Intersection ID: 24458	Main Street: DOVE_COTTAGE_DR	Cross Street: TRIPPER_LN	Location:	NE
ADA ID: 721EB3AF36FA	Ramp Type: PerpDiag	Initial Pass/Fail: Fail	Overall Compliance: No	Severity Score: 8.75

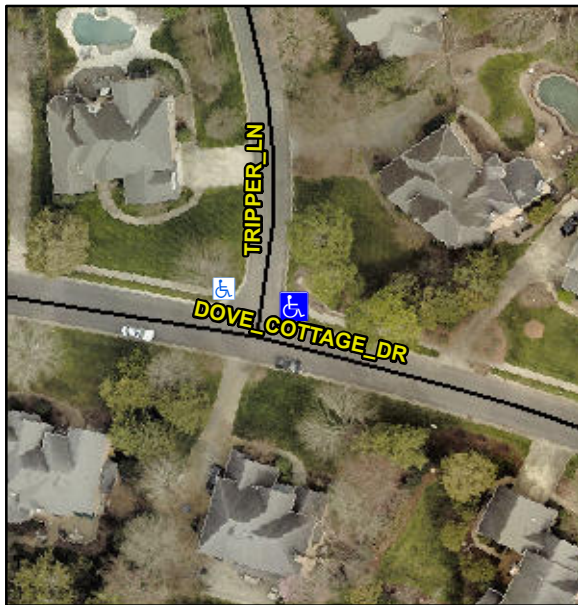
Compliance	Description	Data	Compliance	Description	Data
N/A	Ramp Length (in)	96.0	Yes	Ramp Slope (%)	6.5
No	Ramp Width (in)	43.0	Yes	Ramp XSlope (%)	0.2
N/A	Flare Type LT	N/A	N/A	Flare Type RT	N/A
N/A	Flare Slope LT (%)	N/A	N/A	Flare Slope RT (%)	N/A
N/A	Flare Traversable LT?	N/A	N/A	Flare Traversable RT?	N/A
N/A	Landing Length (in)	N/A	N/A	DWS Provided?	N/A
N/A	Landing Width (in)	N/A	N/A	DWS Contrast?	N/A
N/A	Landing Slope (%)	N/A	N/A	DWS Length (in)	N/A
N/A	Landing X Slope (%)	N/A	N/A	DWS Full Width?	N/A
N/A	Landing Curb? (Y/N)	N/A	N/A	DWS Offset (in)	N/A
N/A	Shared Landing?	N/A			
N/A	Gutter Ponding?	N/A	N/A	Gutter Slope (%)	N/A
N/A	Gutter Lip Ht (in)	N/A	N/A	Gutter X Slope (%)	N/A
N/A	Painted X Walk1?	No	N/A	Painted X Walk2?	No
	X Walk 1 Direction	To NW		X Walk 2 Direction	To S
N/A	X Walk 1 Width (in)	N/A	N/A	X Walk 2 Width (in)	N/A
	X Walk 1 Slope (%)	4.0		X Walk 2 Slope (%)	2.9
	X Walk 1 X Slope (%)	0.2		X Walk 2 X Slope (%)	2.9

N/A	Ramp inside XWalk1?	N/A	N/A	Ramp inside XWalk2?	N/A
	Road Slope (%)	1.5	N/A	Clear Space?	N/A
	Road X Slope (%)	3.5	N/A	Clear Space to XWalk (in)	N/A
N/A	Any Obstructions?	N/A	N/A	Storm Grate/Utility Hazard?	N/A
	Obstruction Type			Storm Grate/Utility Type	
		N/A			N/A
			Yes	Surface Condition? (G/P)	Good

**Remove & Replace Curb Ramp With Two New Directional Ramps or Equivalent.**
